**Item No.**  
**Design Review Committee**  
**January 14, 2016**

**SUBJECT:** **Case 20275: Substantive Site Plan Approval, 1565, 1599, and 1601 South Park Street and 5600 Sackville Street, Halifax**

It is recommended that the Design Review Committee refuse the substantive site plan approval application for a mixed-use development consisting of two buildings at 1565, 1599, and 1601 South Park Street and 5600 Sackville Street, Halifax as shown on Attachment A.

# East Elevation Pavilion & Rental Building

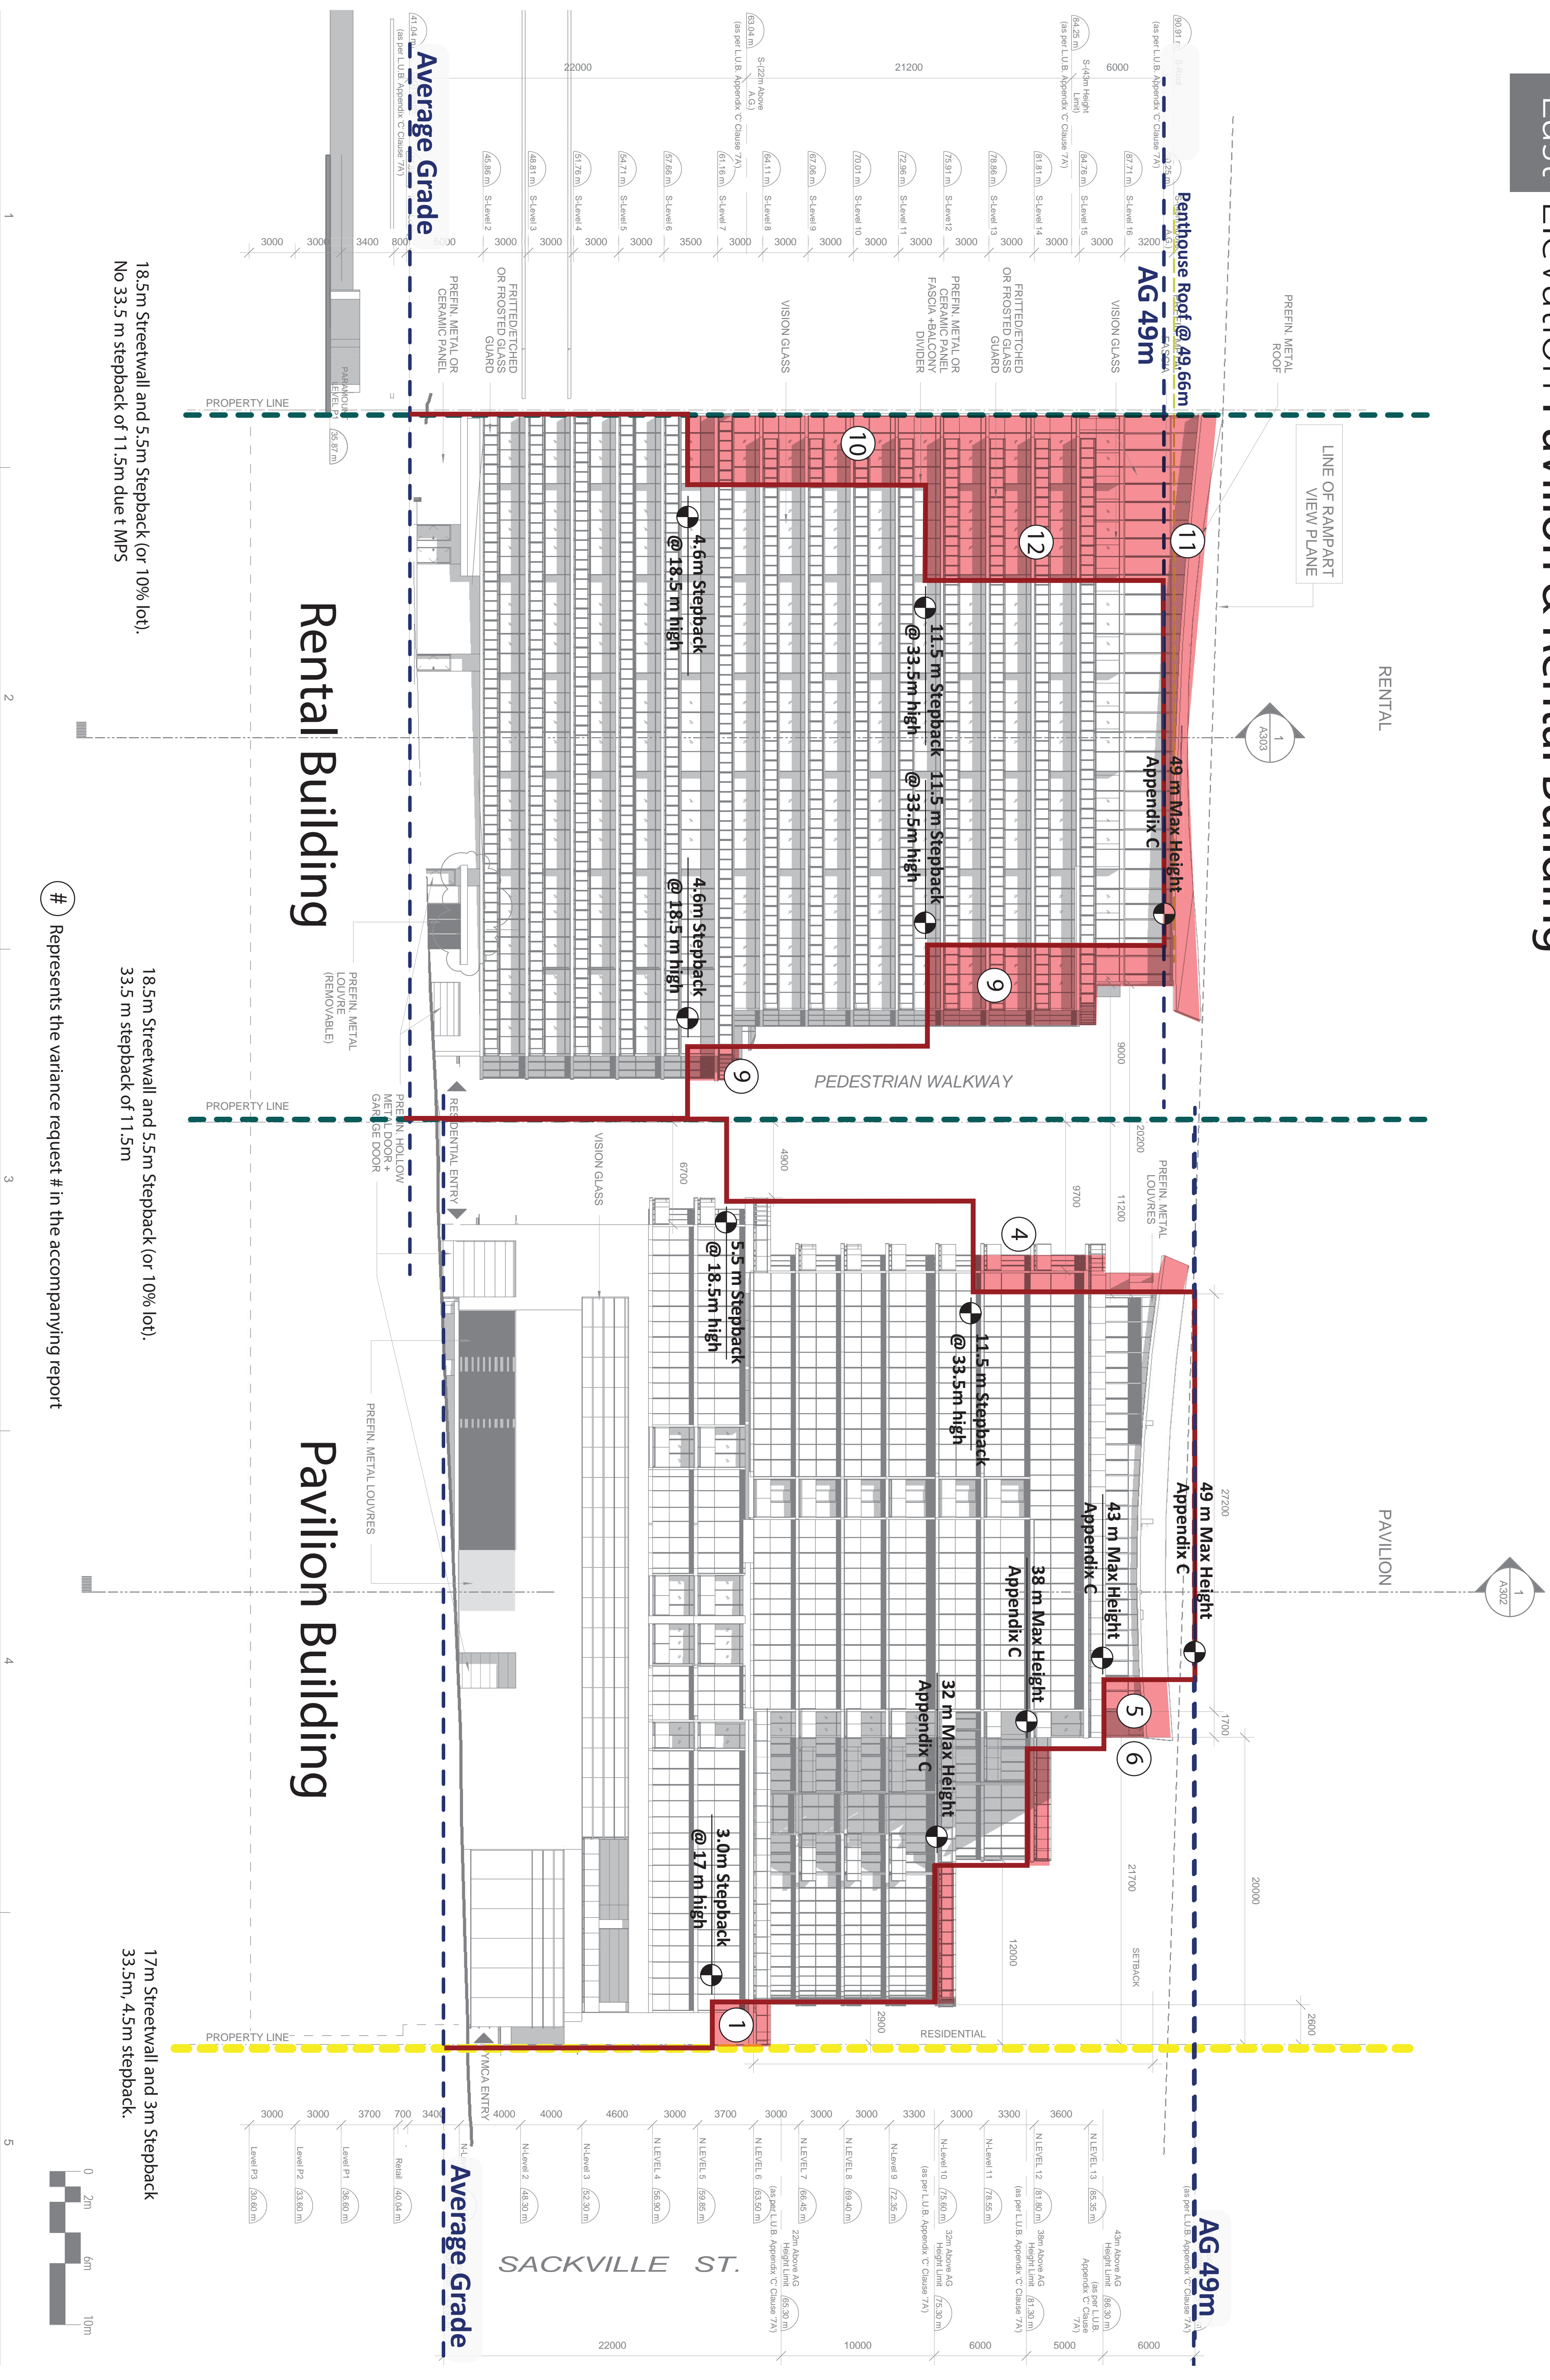
18.5m Streetwall and 5.5m Stepback (or 10% lot).  
No 33.5 m stepback of 11.5m due t MP5

# South Elevation Rental Building

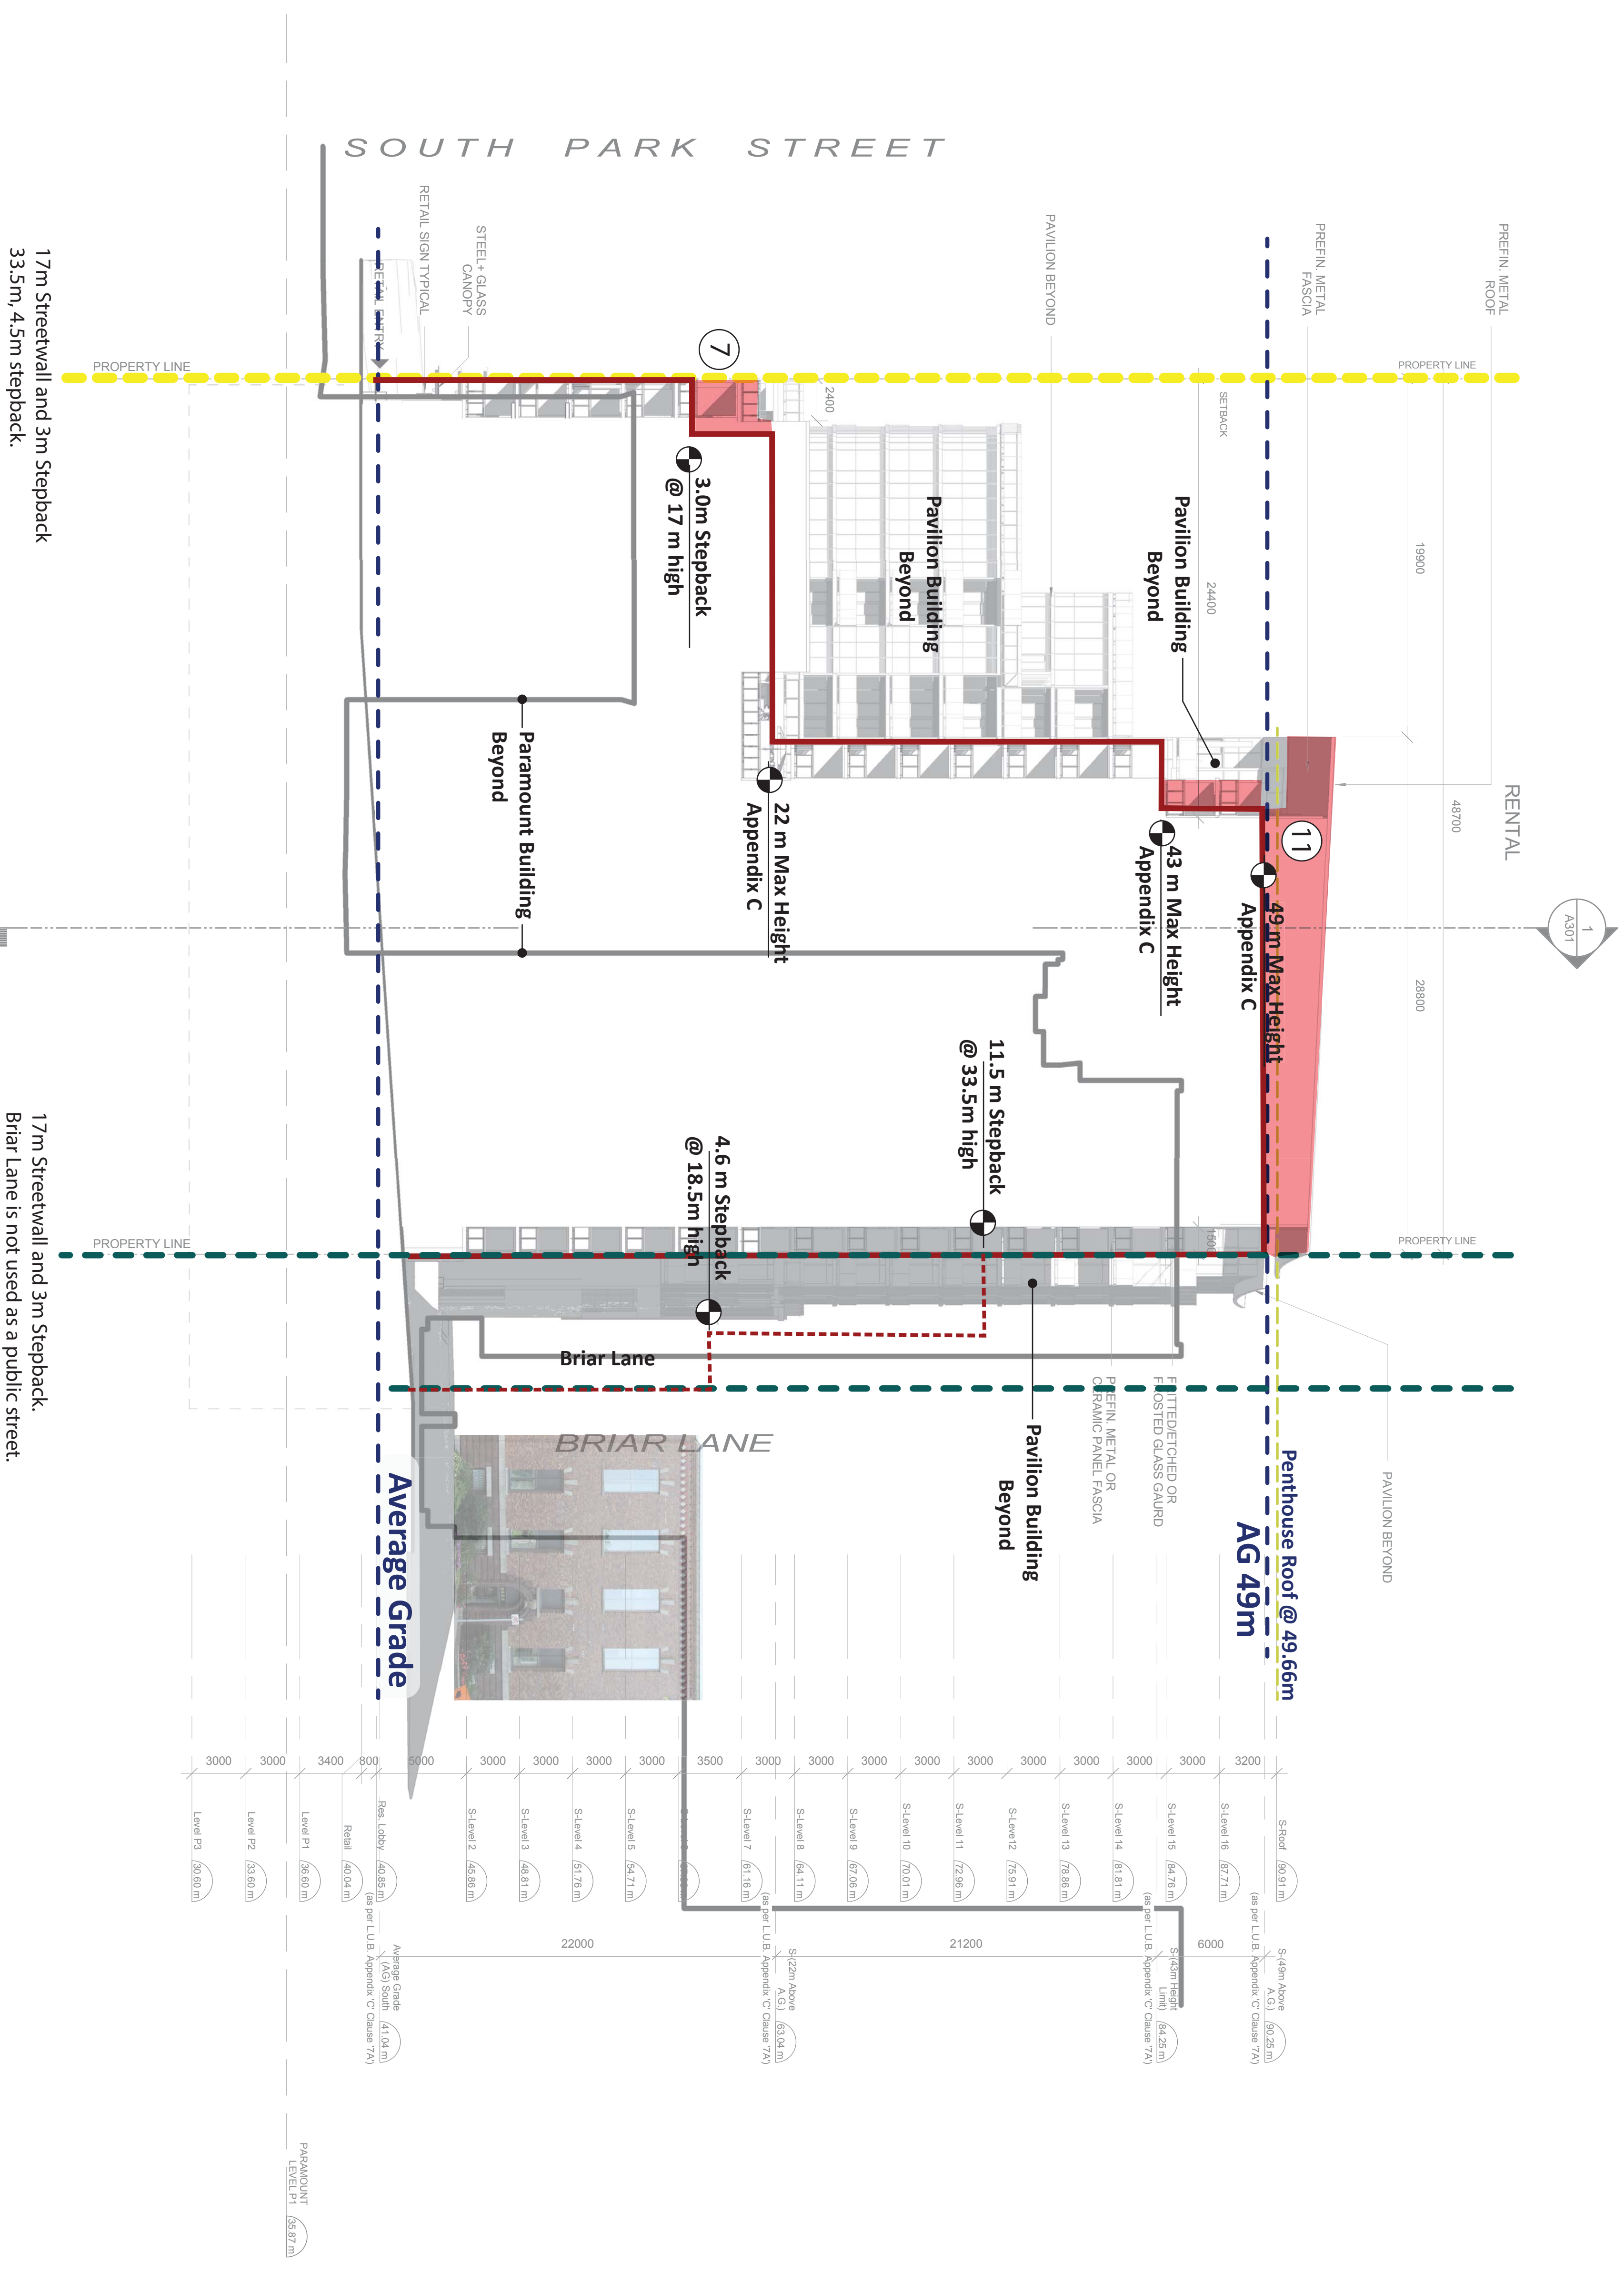
17m Streetwall and 3m Stepback.  
33.5m, 4.5m stepback.

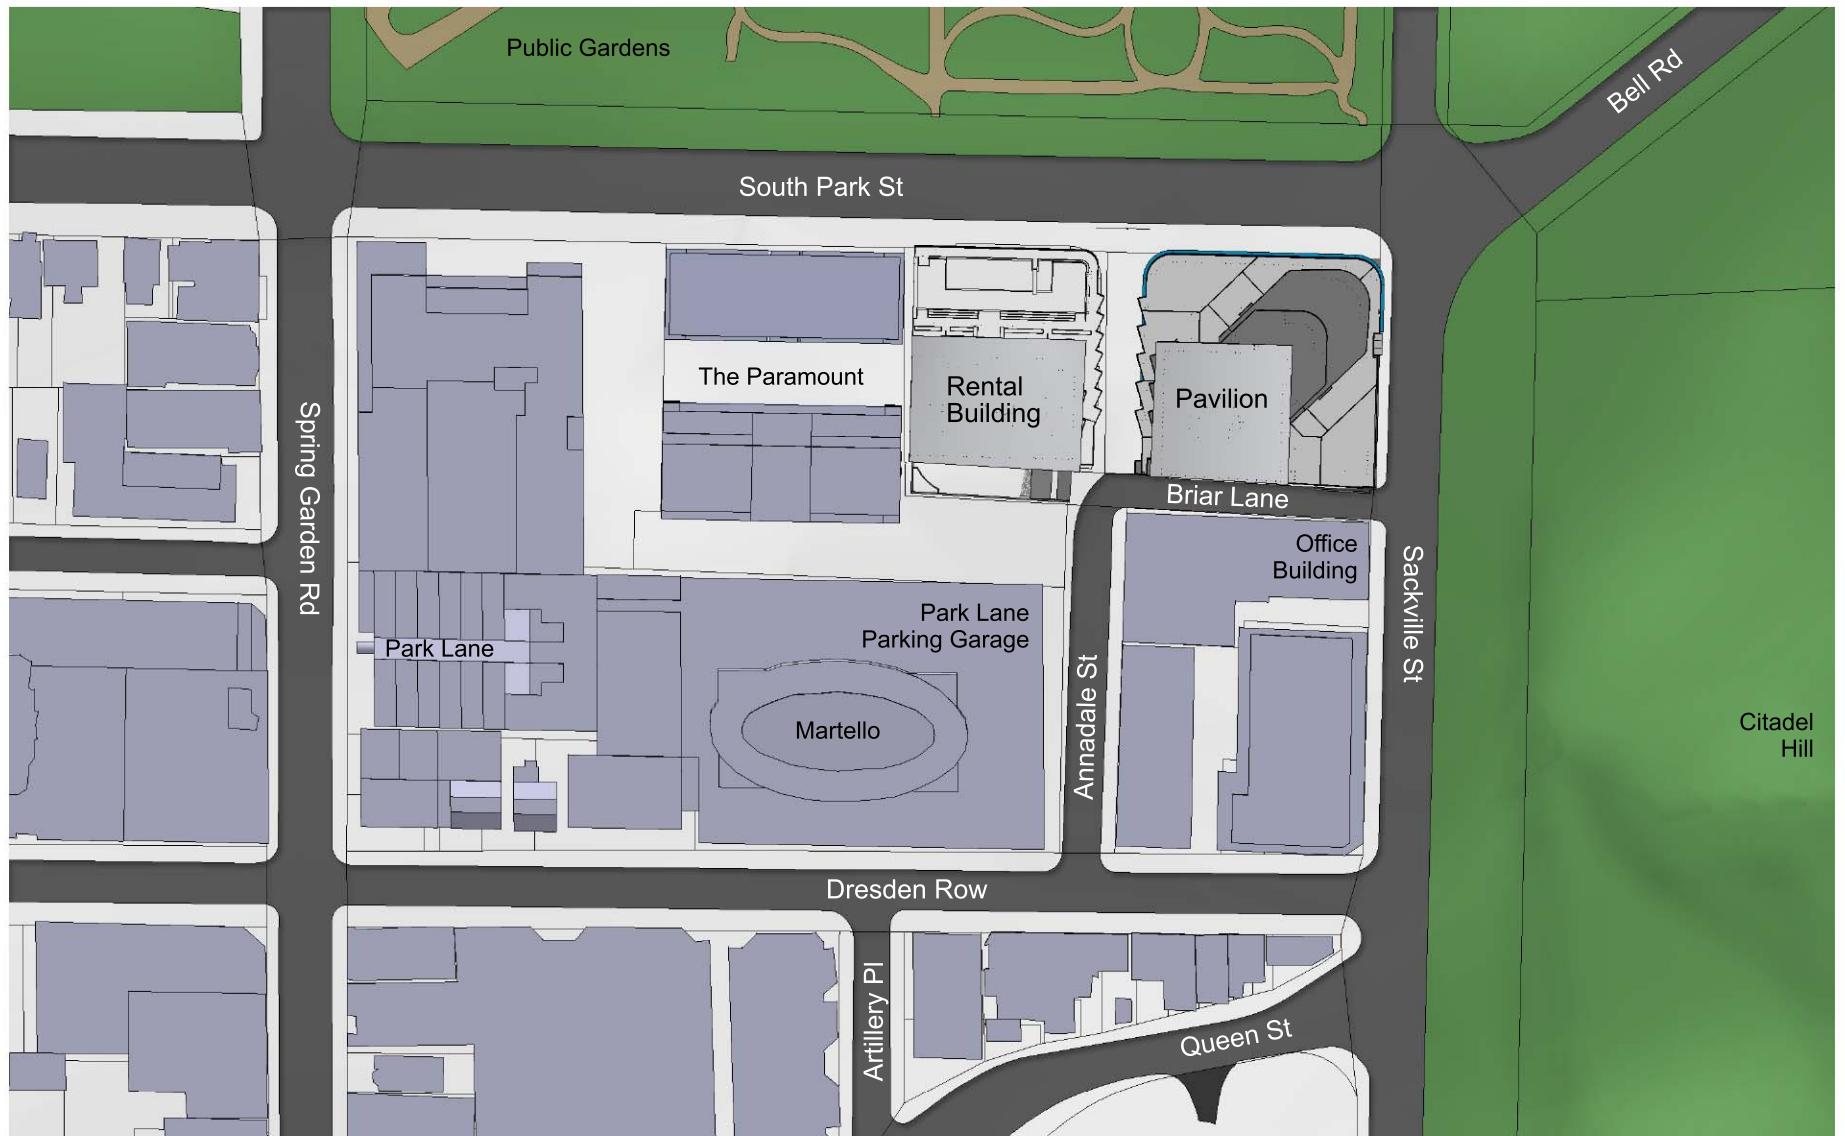
**14) Streetwall Width on Annandale: Section 9, Subsection 6 requires that streetwalls occupy a minimum of 80 percent of width of a streetline on Non-Central Blocks.**

*Non-compliance:* The driveway leading to the parking garage occupies a small portion of the site that fronts onto Annandale Street and consequently there is an absence of a streetwall in this location.

*Variance option:* Section 3.6.4 of the Design Manual allows for a variance to the tower width requirements, subject to meeting the following criteria:
